ENGINE - FUEL AND CONTROL - NACELLE - POWERPLANT - PIPE ASSEMBLY, P2T2 - REPLACEMENT OF
- CATEGORY CODE 7 - MOD.NAC-73-0118

V2500-NAC-73-0118

SERVICE BULLETIN

P2T2 Pipe Assembly Replacement
Fig.1

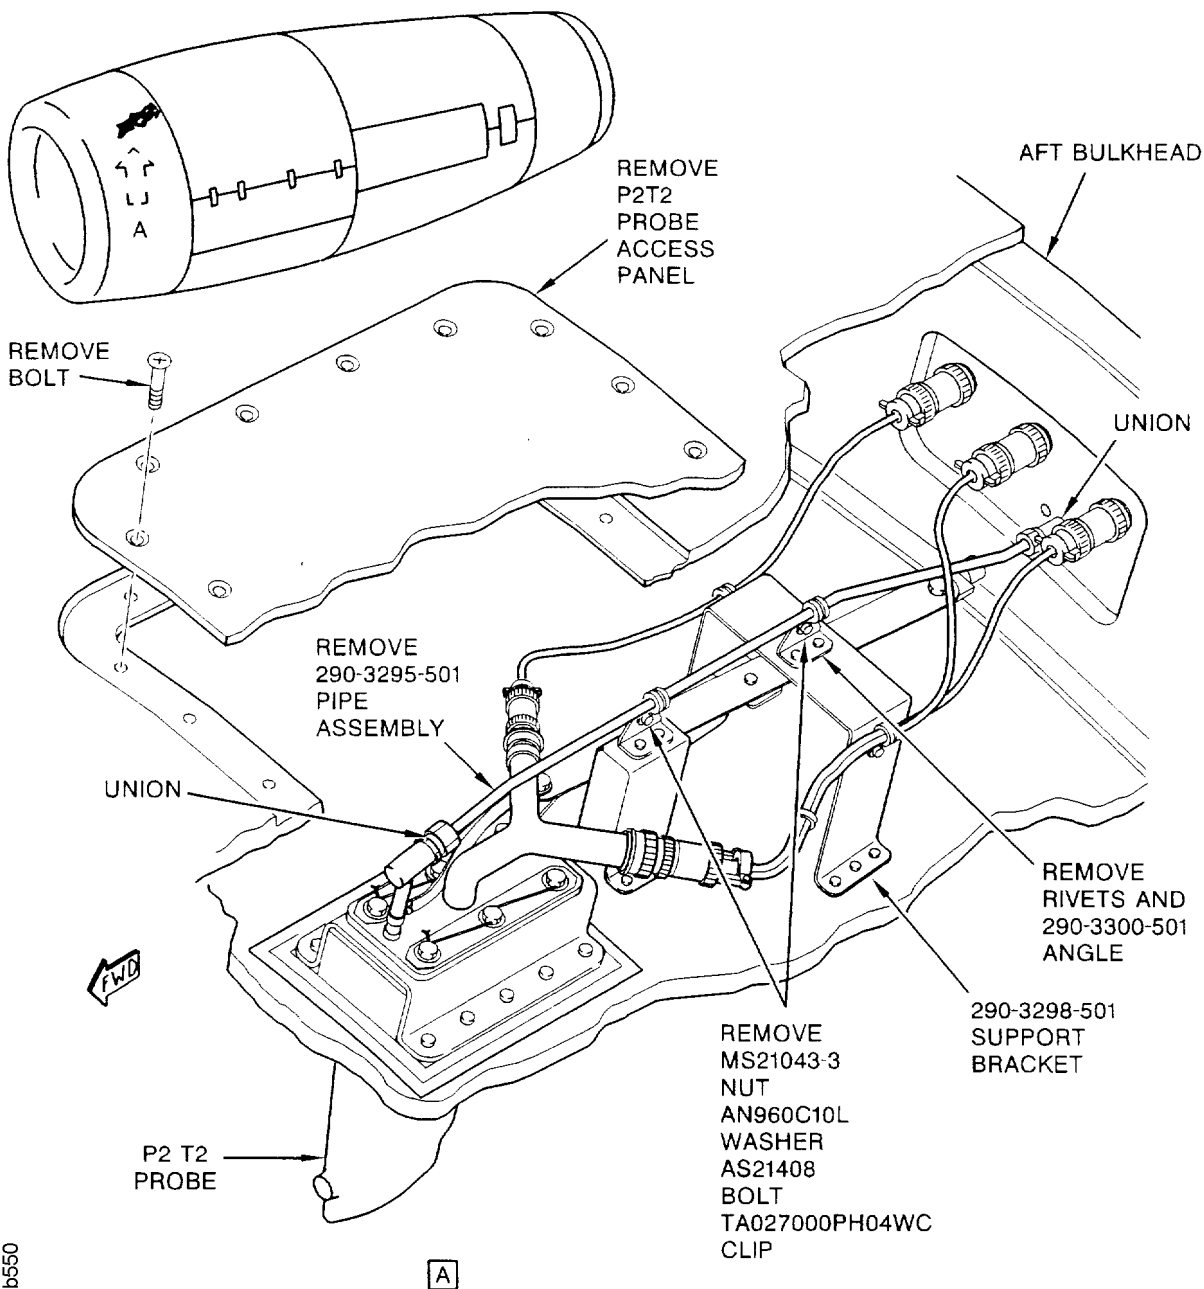
Remove the nose cowl rigid P2T2 pipe assembly. Remove one clipping point.
Install the new flexible pipe assembly with one less clip.

- (1) Remove the bolts and the probe access panel. Refer to Figure 1.

- (1) Remove the nuts MS21043-3, bolts AS21408, washers AN960C10L, and clips TA027000PH04WC. Discard one nut, one bolt, one washer, and one clip. Refer to Figure 1.
- (2) Remove the pipe assembly 290-3295-501. Refer to Figure 1.
- (3) Remove the two rivets and the 290-3300-501 angle from the 290-3298-501 support bracket.
- (4) Install the pipe assembly AE709614-2 on the aft bulkhead union and the P2T2 sensor union. Torque the coupling nuts to 135-145 lbfin (15.25-16.38 Nm). Refer to Figure 2.
- (5) Attach the pipe assembly to the bracket with the clip TA027000PH04WC, the bolt AS21408, the washer AN960C10L, and the nut MS21043-3. Refer to Figure 2.

P2T2 Pipe Assembly Replacement
Fig.2

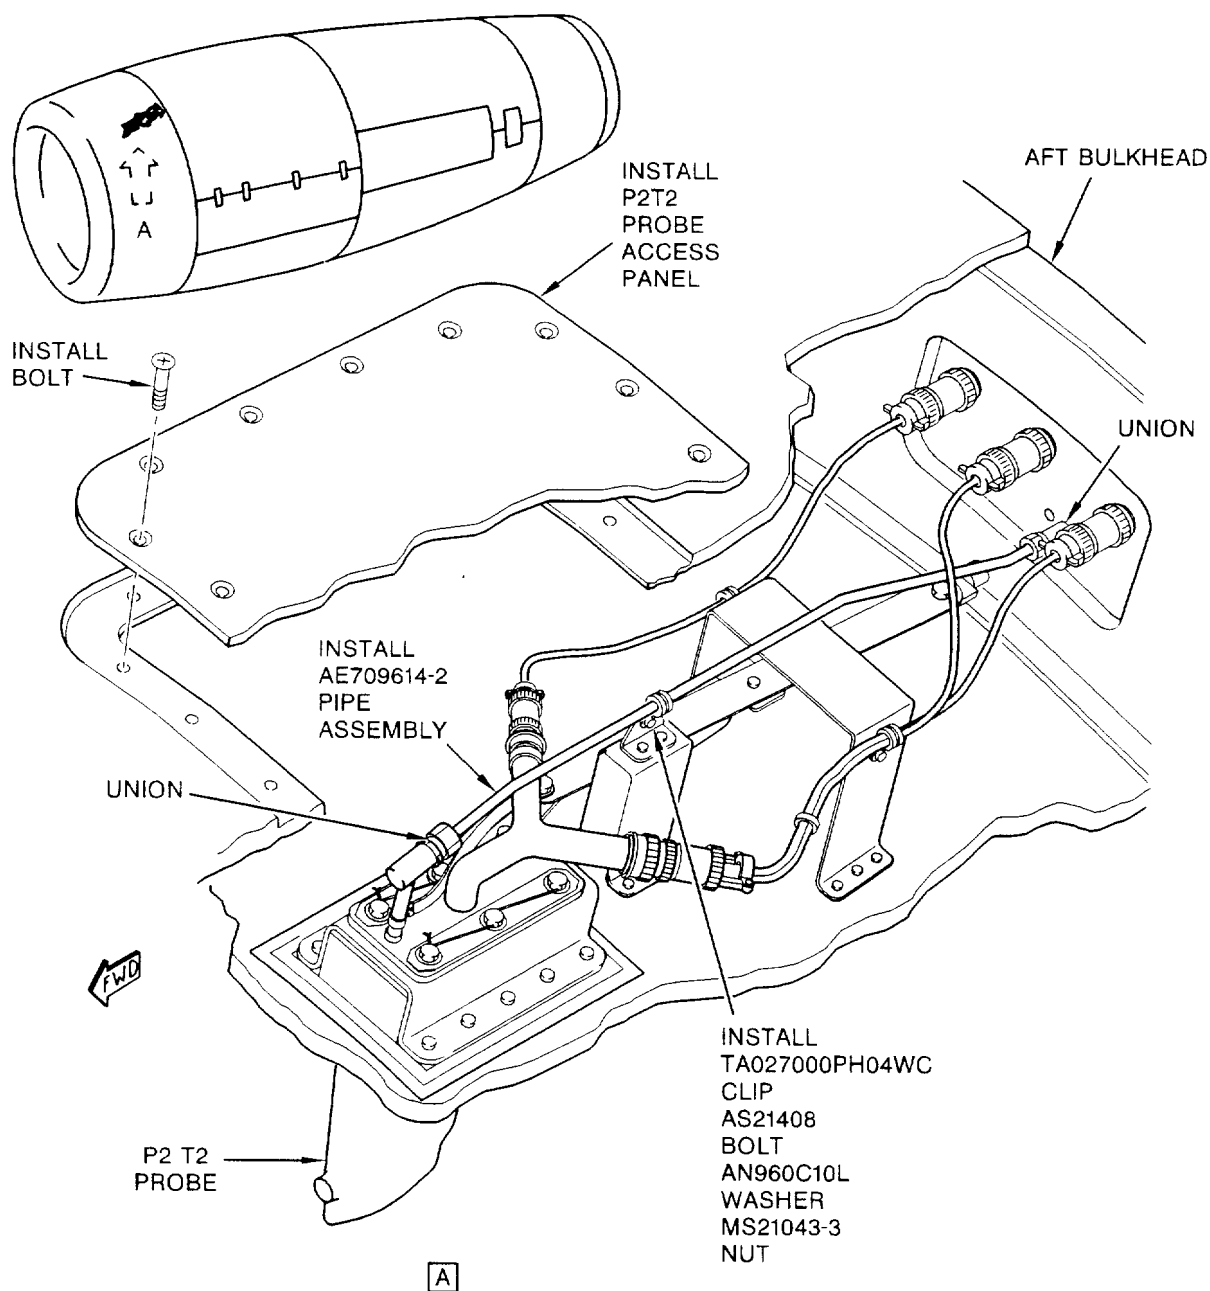
- (1) Install the probe access panel with the bolts. Wet install the bolts with jointing compound (CoMat 04-005). Torque the bolts to 40 lbfin (4.52 Nm). Refer to Figure 2.
